Vertical Section

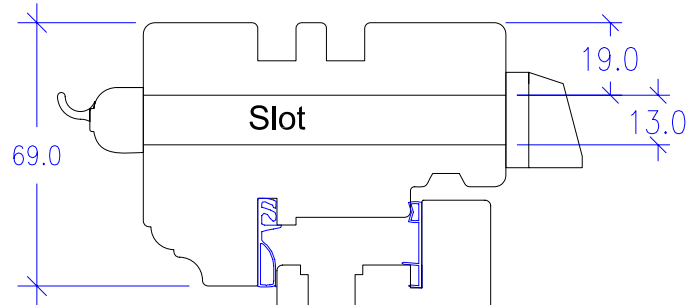
Frame top rail increased from 55mm to 69mm to accommodate Trickle Vent

Standard Vent TTF Slimline 2500-13 slot size 265 x 13

If Frame is under 350mm is width use TTF Slimline 1250-13, Slot size 133 x 13
